Re: Turkey Point Nuclear Generating Station Units 3 and 4 Docket Nos. 50-250 and 50-251 License Amendment Request No. 221: Application to Revise Technical Specifications to Adopt TSTF-510, "Revision to Steam Generator Program Inspection Frequencies and Tube Sample Selection," Using the Consolidated Line Item Improvement Process

Turkey Point Units 3 & 4 License Amendment Request for TSTF-510, "Revision to Steam Generator Program Inspection Frequencies and Tube Sample Selection," Using the Consolidated Line Item Improvement Process

PROPOSED TECHNICAL SPECIFICATION CHANGES (MARK-UP)

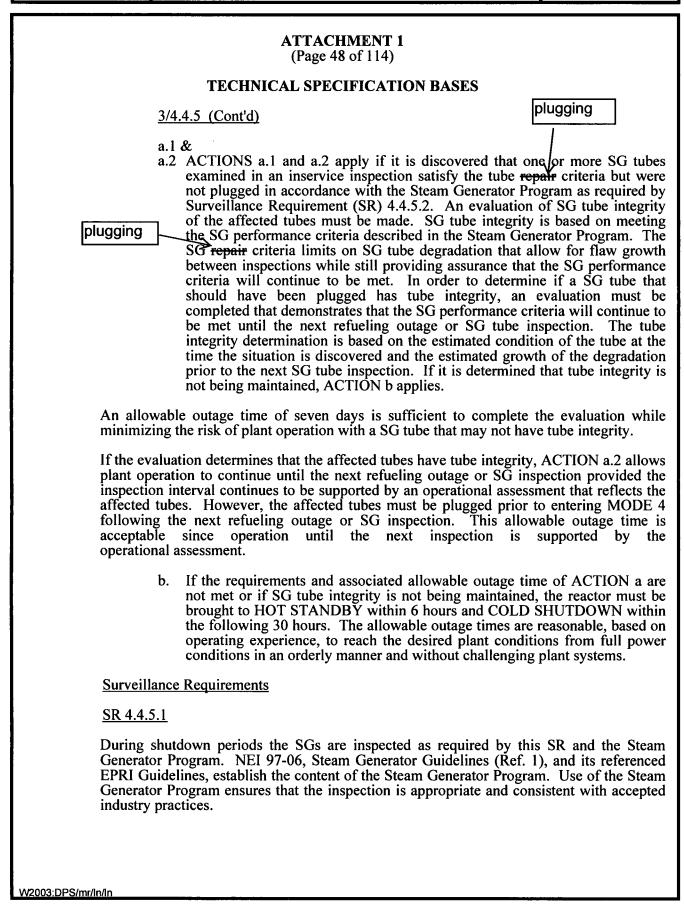
ATTACHMENT 1 (Page 46 of 114)			
	TECHNICAL SPECIFICATION BASES		
	<u>3/4.4.5 (Cont'd)</u>		
	Limiting Condition for Operation (LCO)		
plugging plugging	The LCO requires that SG tube integrity be maintained. The LCO also requires that all SG tubes that satisfy the repair criteria be plugged in accordance with the Steam Generator Program.		
	During a SG inspection, any inspected tube that satisfies the Steam Generator Program repair criteria is removed from service by plugging. If a tube was determined to satisfy the repair criteria but was not plugged, the tube may still have tube integrity.		
	In the context of this Specification, a SG tube is defined as the entire length of the tube, including the tube wall from 17.28 inches below the top of the tubesheet on the hot leg side to 17.28 inches below the top of the tubesheet on the cold leg side. The tube-to-tubesheet weld is not considered part of the tube.

A SG tube has integrity when it satisfies the SG performance criteria. The SG performance criteria are defined in Specification 6.8.4.j and describe acceptable SG tube performance. The Steam Generator Program also provides the evaluation process for determining conformance with the SG performance criteria.		
	There are three SG performance criteria: structural integrity, accident induced leakage, and operational leakage. Failure to meet any one of these criteria is considered failure to meet the LCO.		
	The structural integrity performance criterion provides a margin of safety against tube burst or collapse under normal and accident conditions, and ensures structural integrity of the SG tubes under all anticipated transients included in the design specification. Tube burst is defined as, the gross structural failure of the tube wall. The condition typically corresponds to an unstable opening displacement (e.g., opening area increased in response to constant pressure) accompanied by ductile (plastic) tearing of the tube material at the ends of the degradation. Tube collapse is defined as, for the load displacement curve for a given structure, collapse occurs at the top of the load verses displacement curve where the slope of the curve becomes zero. The structural integrity performance criterion provides guidance on assessing loads that have a significant effect on burst or collapse. In that context, the term significant is defined as an accident loading condition other than differential pressure is considered significant when the addition of such loads in the assessment of the structural integrity performance criterion could cause a lower structural limit or limiting burst/collapse to be established. For tube integrity evaluations, except for circumferential degradation, axial thermal loads are classified as secondary loads. For circumferential degradation, the classification of axial thermal loads as primary or secondary loads will be evaluated on a case-by-case basis. The division between primary and secondary classifications will be based on detailed analysis and/or testing.
